SUBJECT: Forwards responses to questions raised re fire protection analysis.Diesel generator room drawings encl.

November 29, 1979
LDR-79-326

QUESTIONS AND ANSWERS CONCERNING
THE
DUANE ARNOLD ENERGY CENTER
FIRE HAZARD ANALYSIS

FOR INFORMATION ONLY
1007 - A8-111

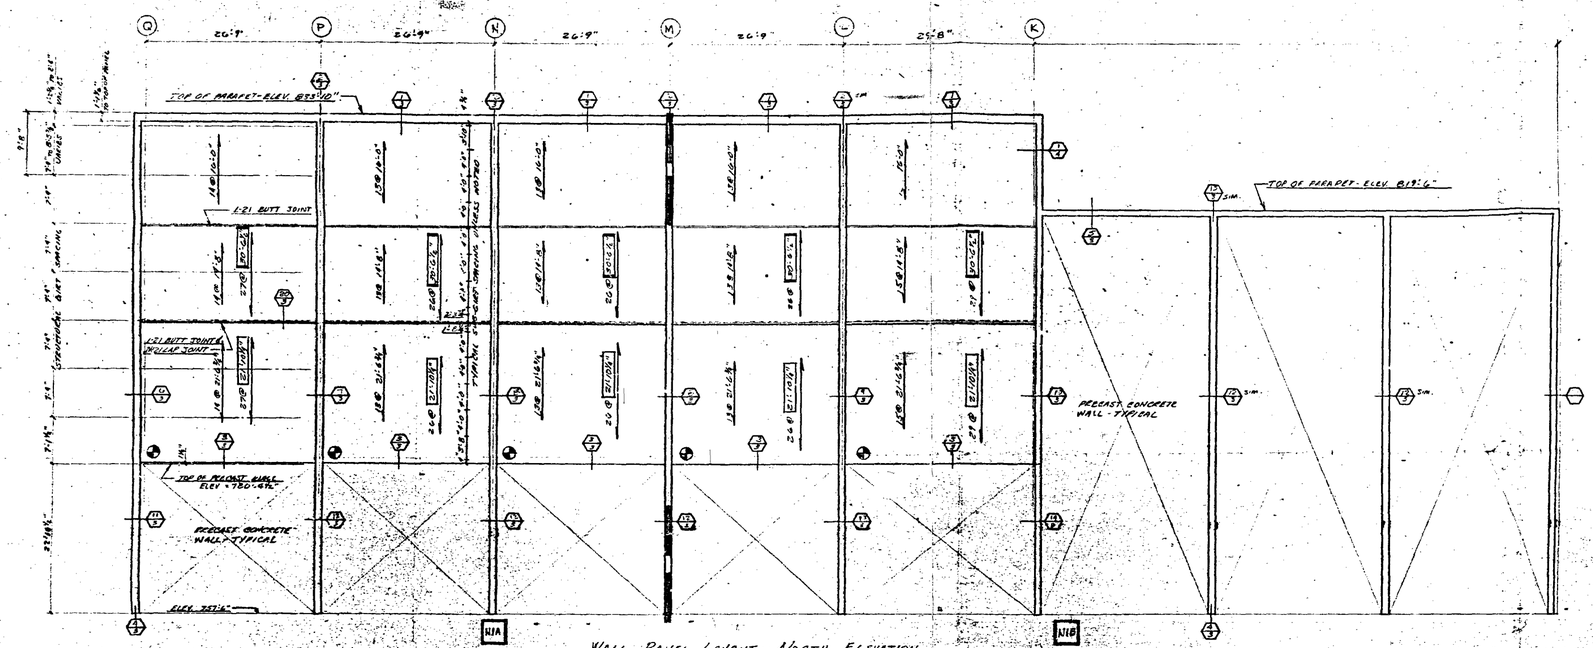
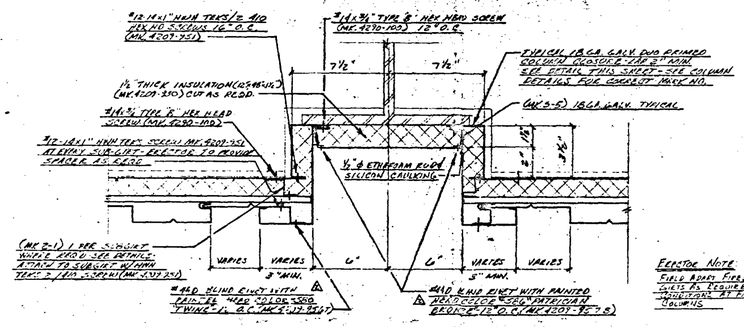
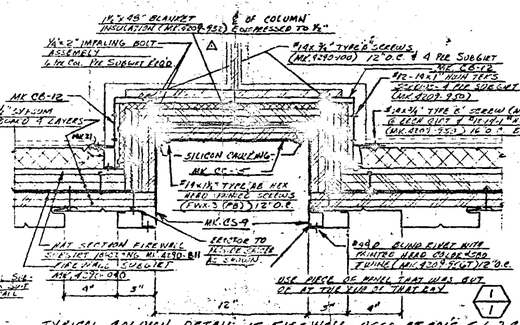
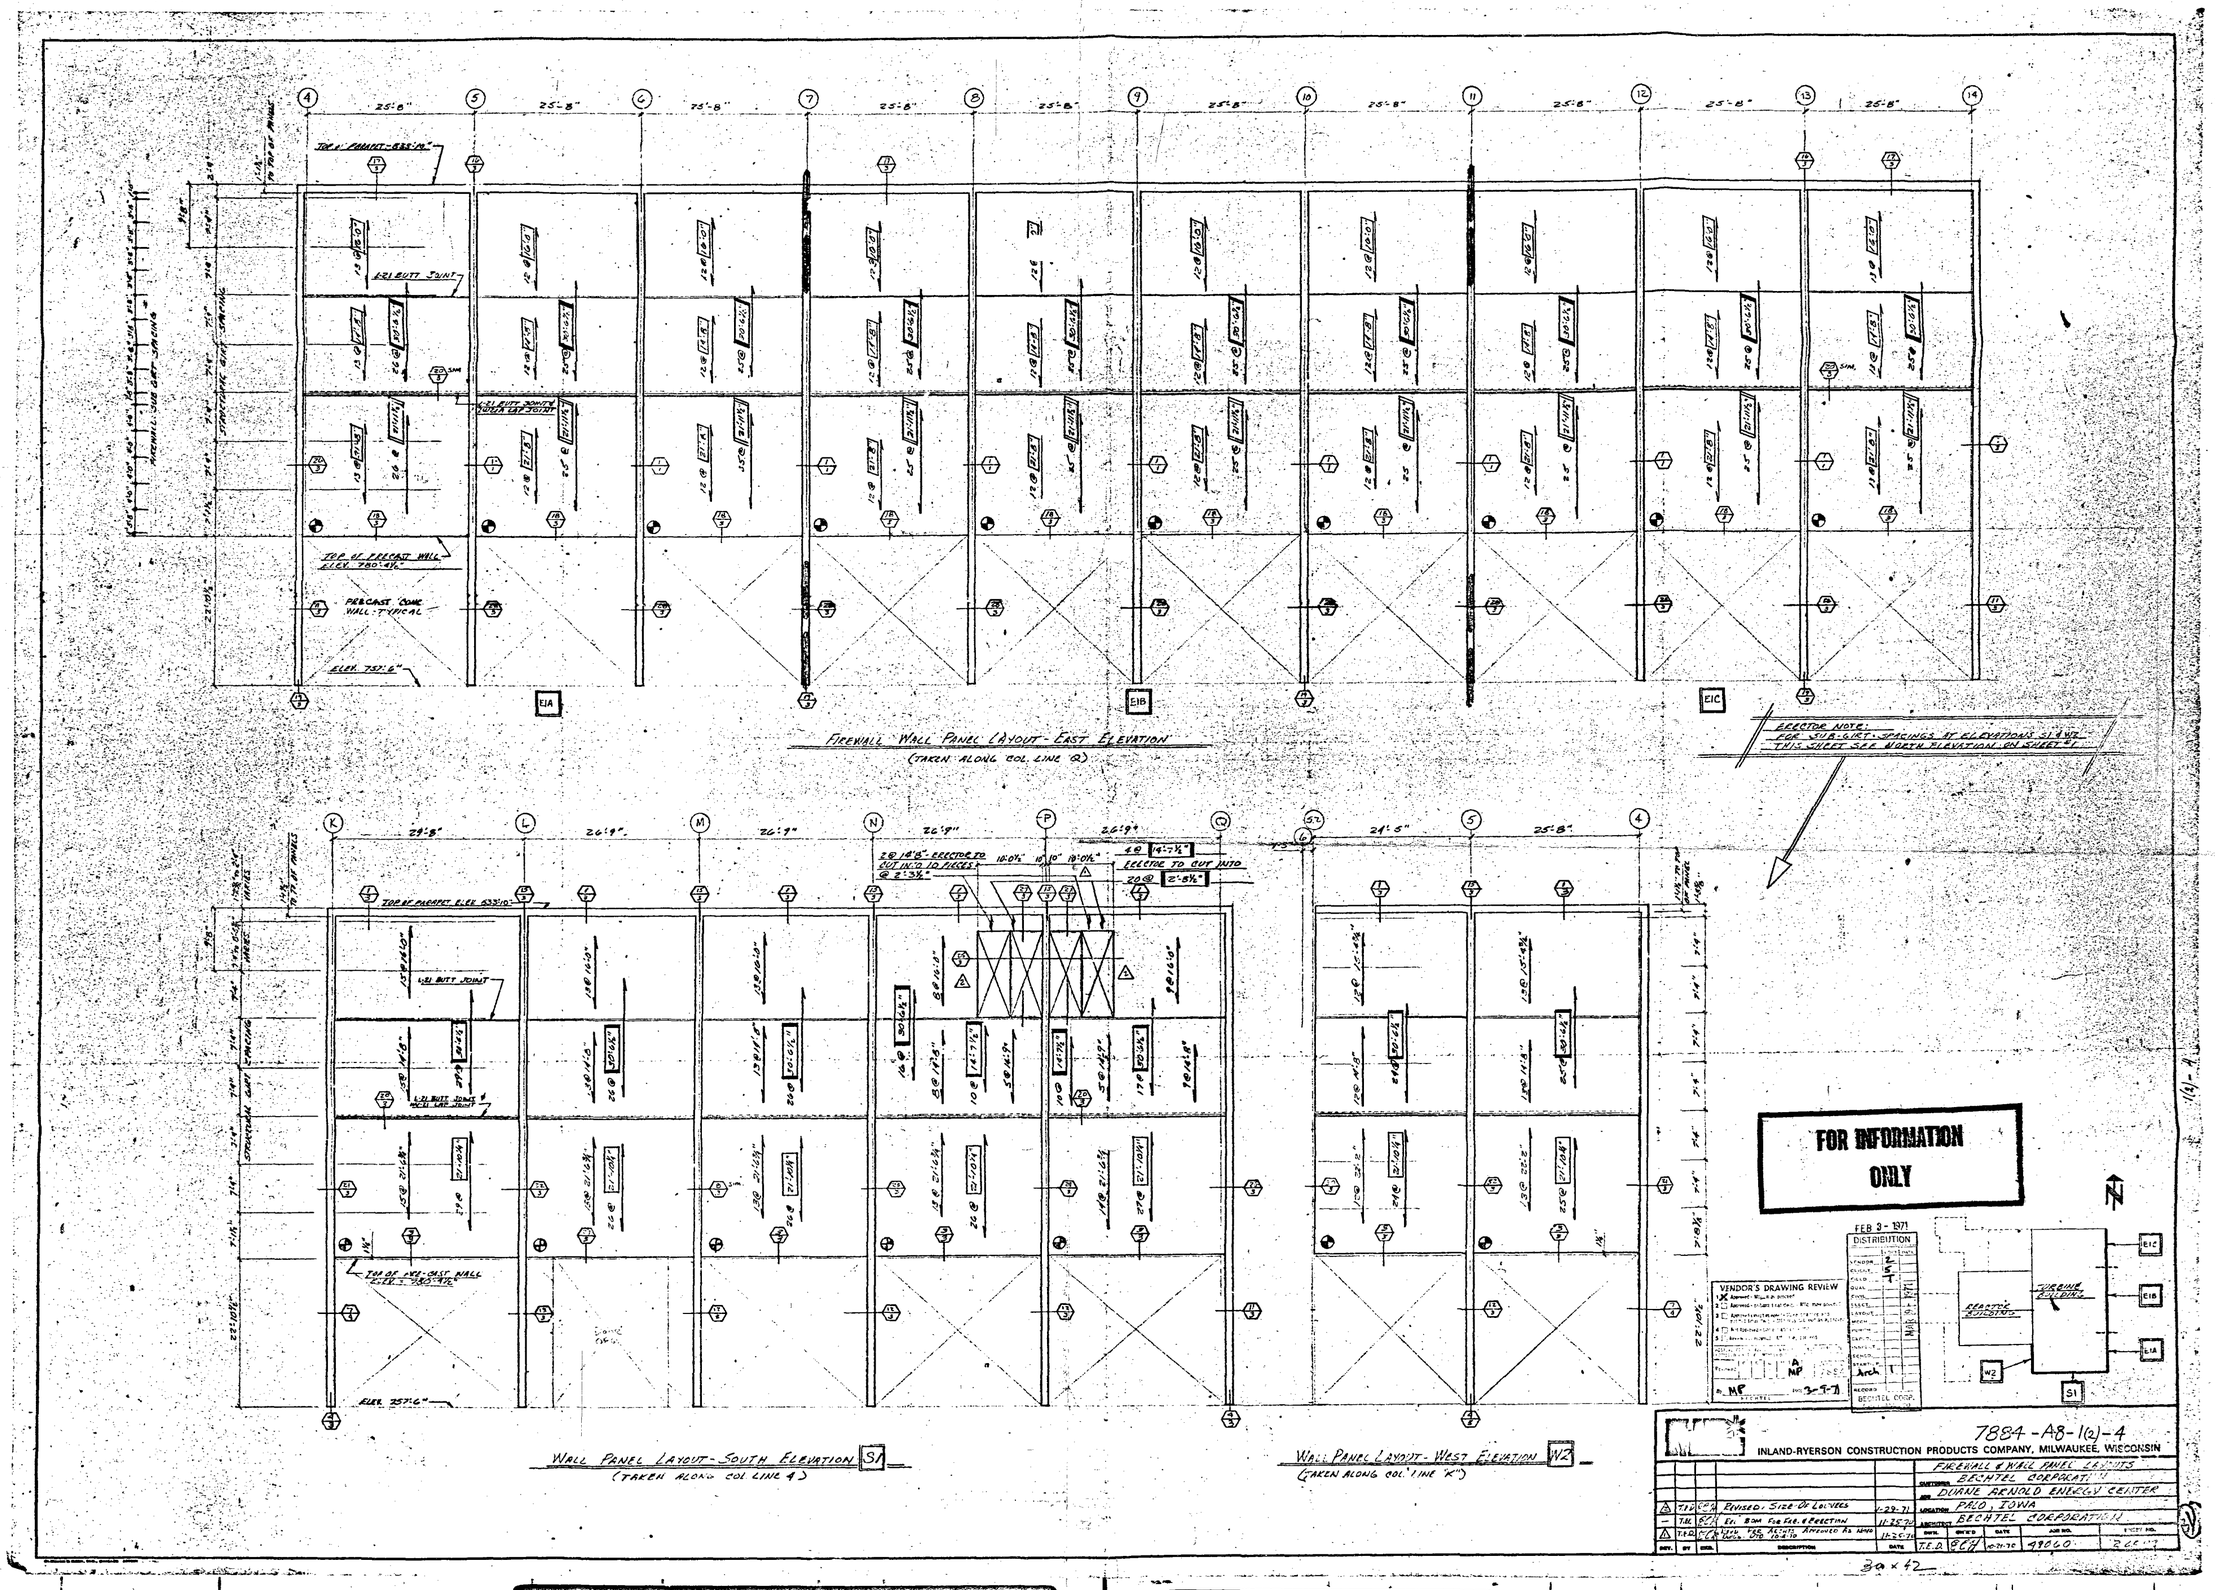
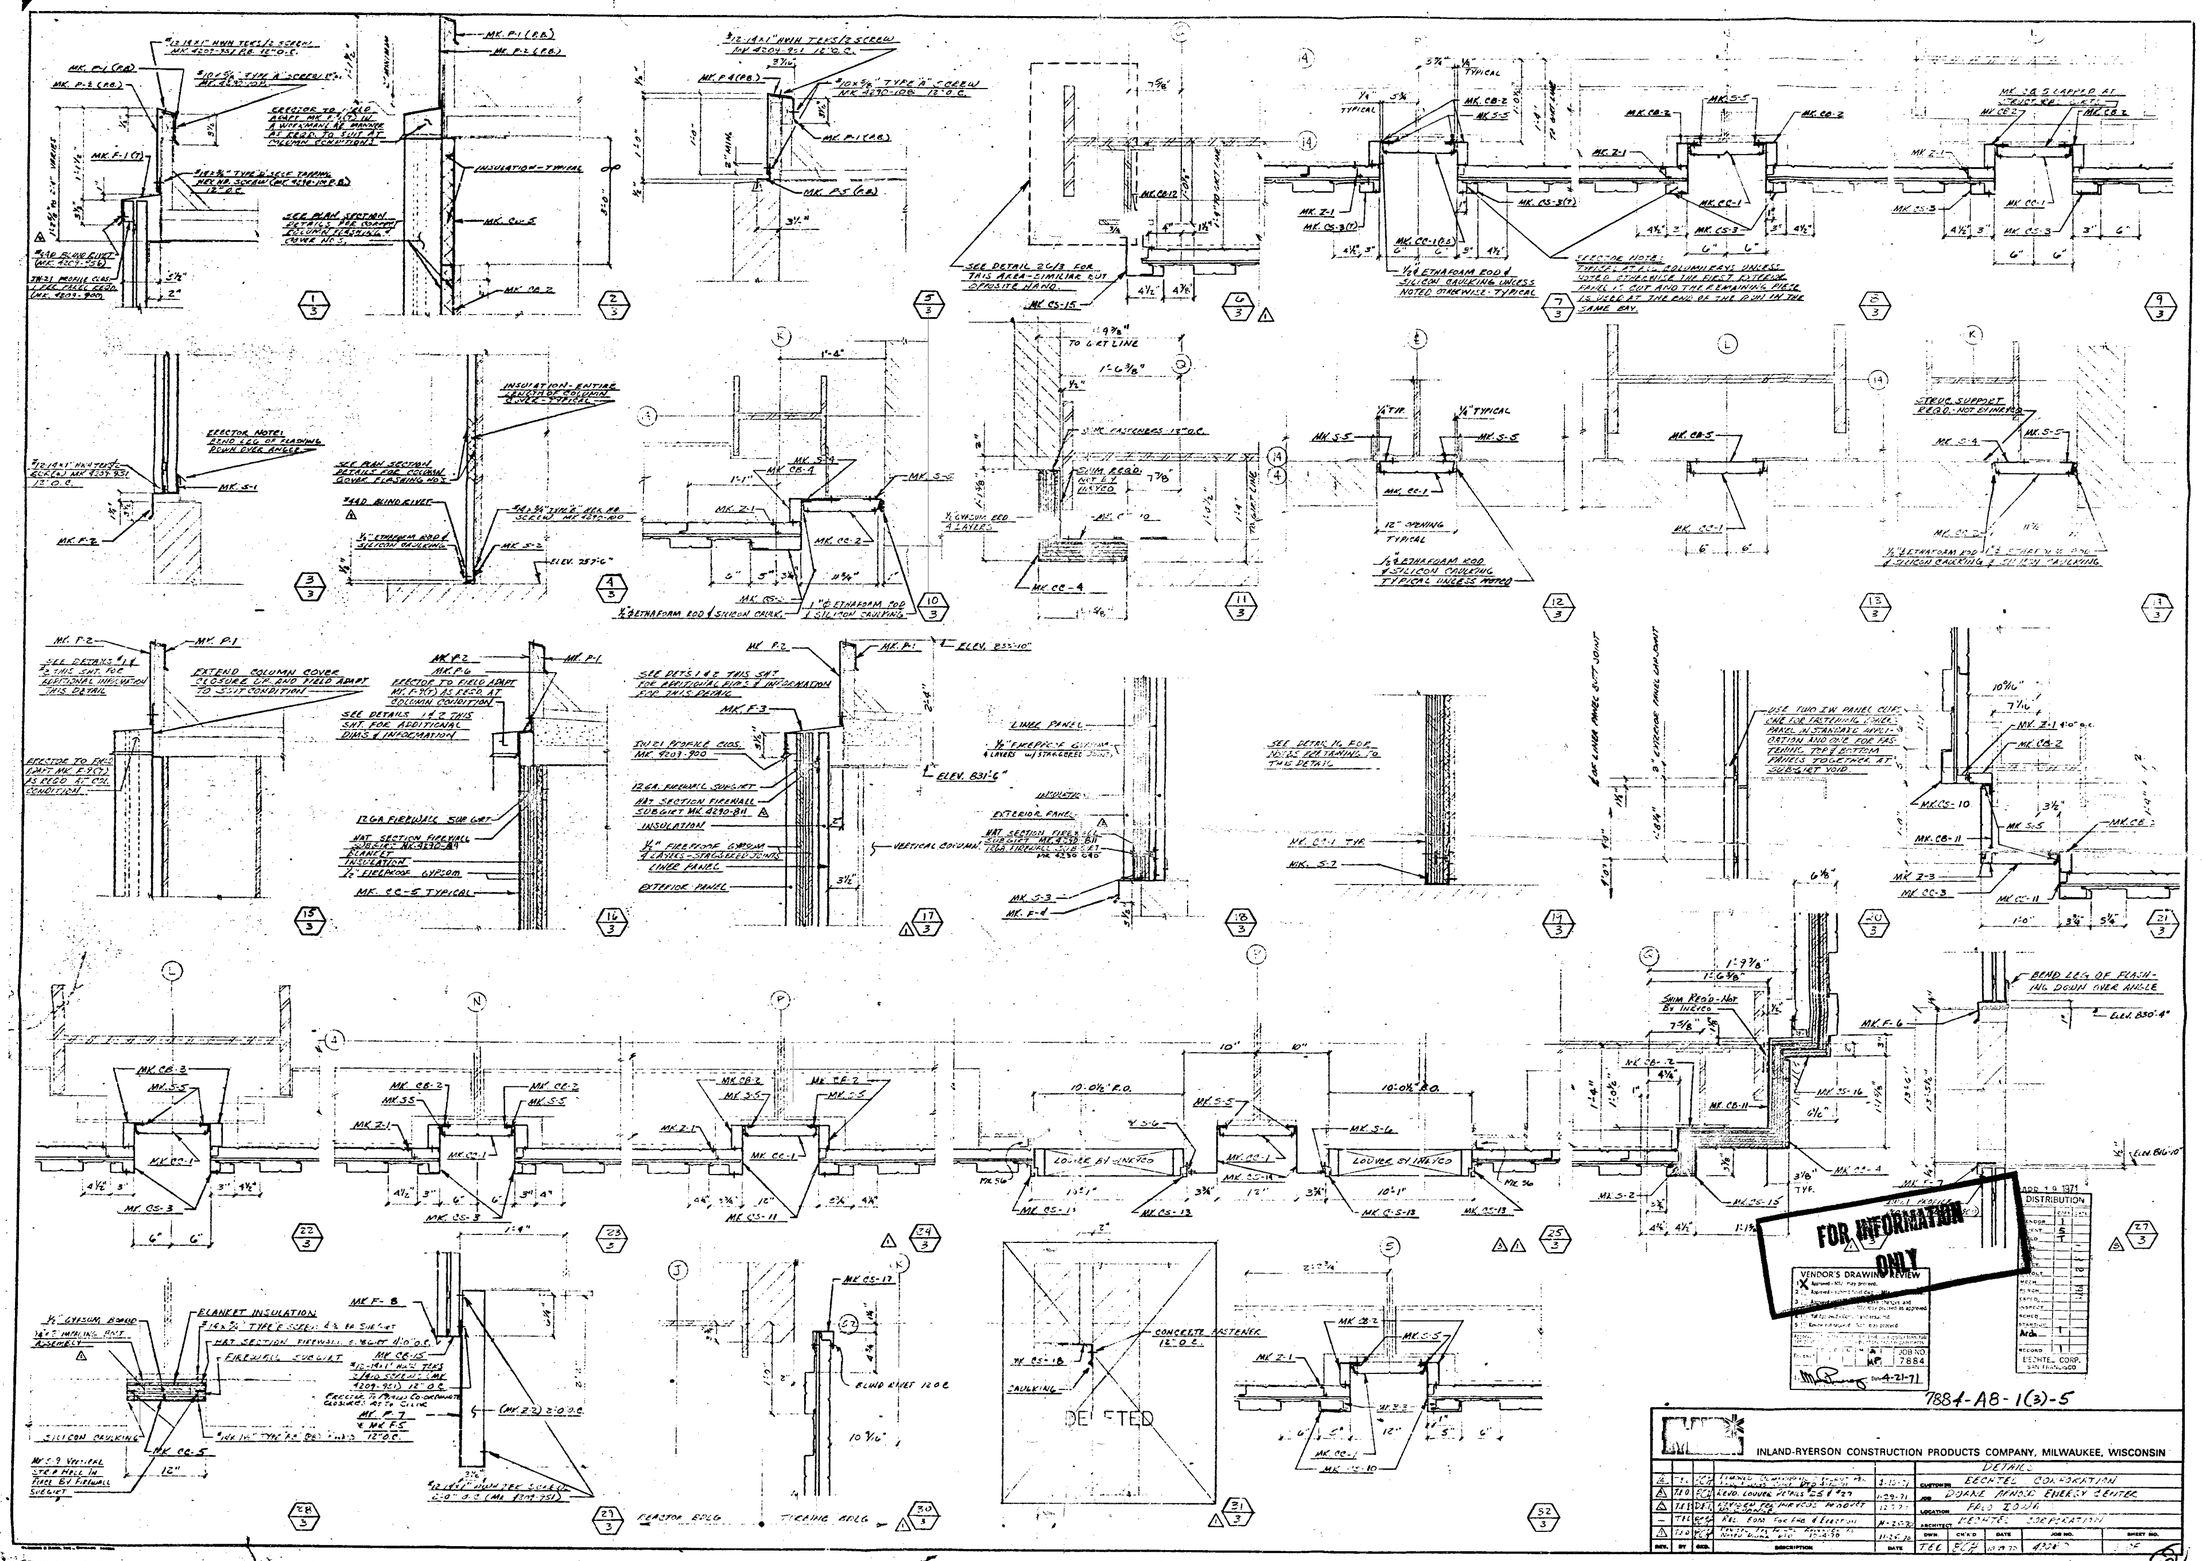
10. Between Zone 8B and external to the TB (east) there is a transformer next to the outside of the wall. With regard to the insulation, how is it secured, and what is its quality and thickness?

For the turbine building column insulation, refer to attached drawings A8-1(1), A8-1(2), A8-1(3).
